LINESTEIN RE TECTONICS

Mr. Ralph Stein, Associate Director
Office of Systems Integration and Regulations
Office of Civilian Radioactive Waste Management
U. S. Department of Energy, RW-24
Washington, D. C. 20545

PROBABILITY OF VOLCANISM AT YUCCA MOUNTAIN

COMPARISON OF VOLCANIC SCENARIOS

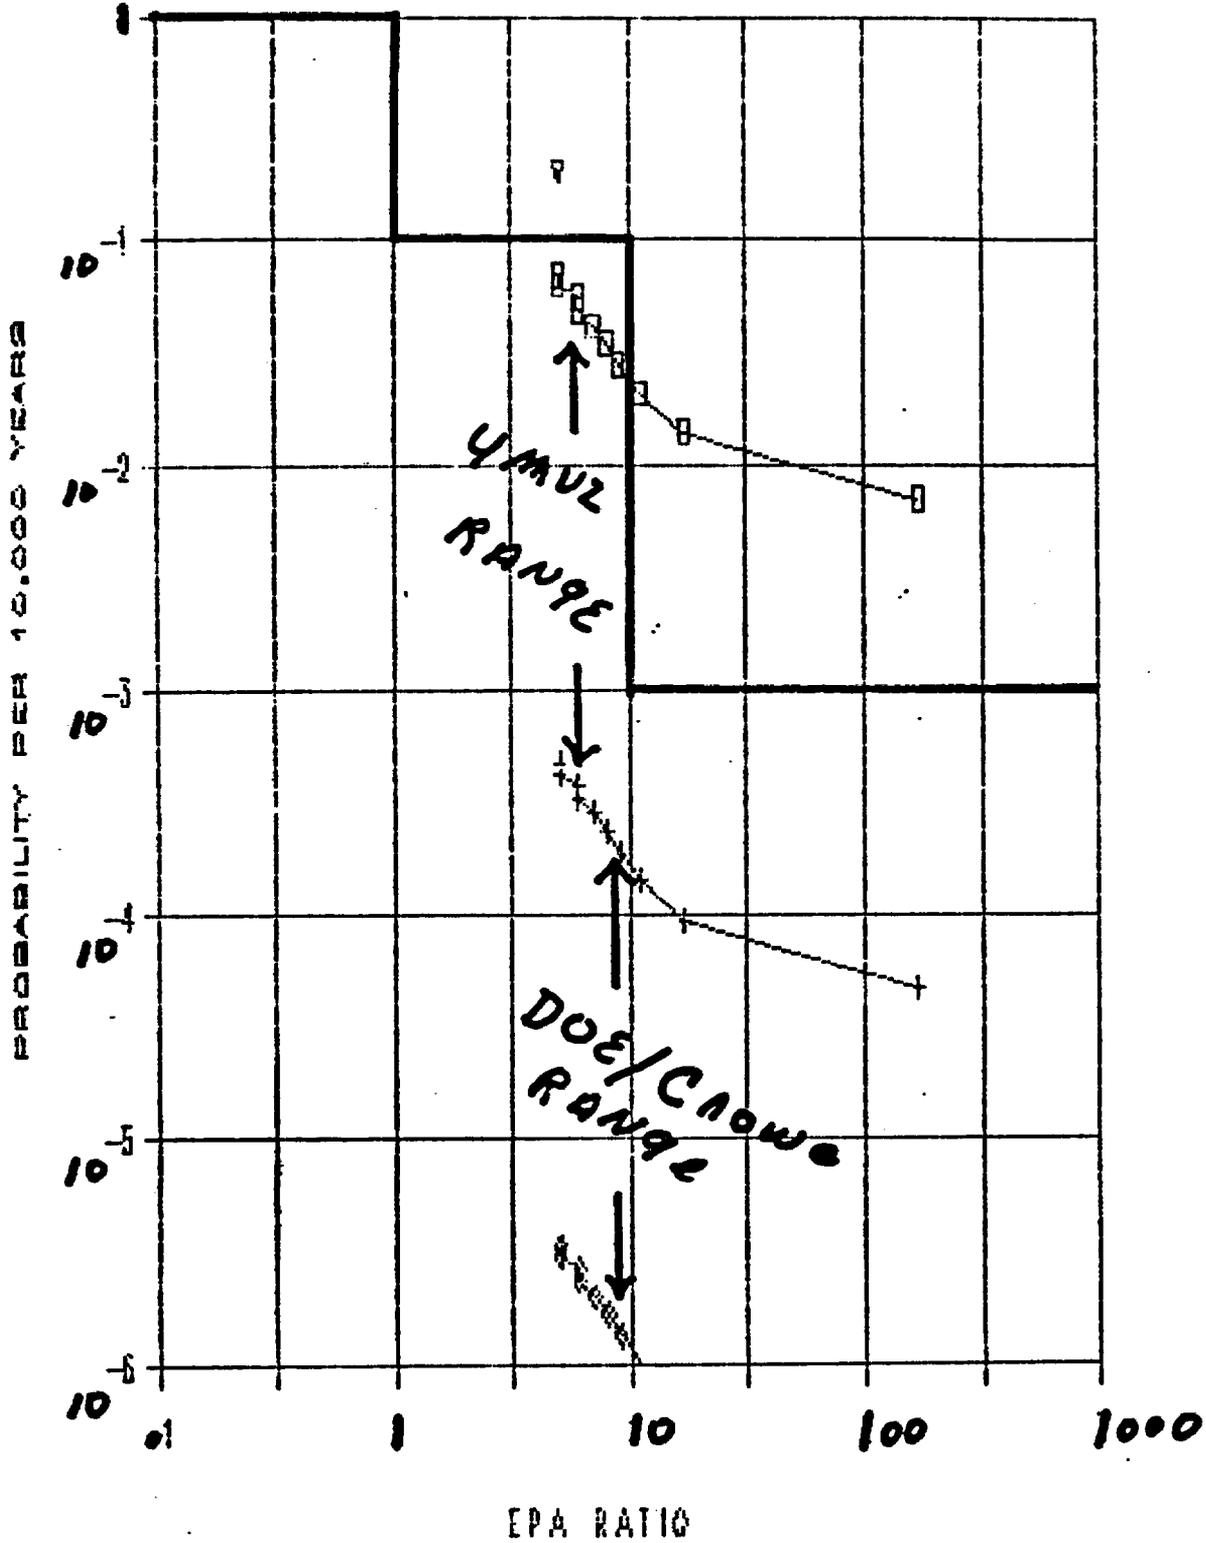
The potential for hydrovolcanic activity and consideration of mapped plug size both suggest that consequence analysis based on dike width and the like, as has been used in all previous analysis, could be non conservative. This can be supported by simple calculations which assume a dike traversing the repository along one continuous room. Assumptions which total the number of canisters which could be effected and assume straight transposition of this material to the surface could result in much higher numbers than these cases are assuming.

To allow a comparison of the various scenarios discussed in this note I am attaching two drawings showing the interpreted range in effects as would be expressed on a CCDF chart. The fact that this is being expressed as lines, rather than points, is to take into consideration radioactive decay. I have used .1 and .3 percent disruption of the repository for the base cases as these values approximately correspond to the measured sizes of the two plugs. The probability values presented do not consider the potential effects of multiple eruptions or increasing the zone of influence around the site, therefore, I consider the numbers as unconservative. The consequence values also do not cover the full range -- I could come up with more or less in many ways -- but are probably reasonable approximations of expected values.
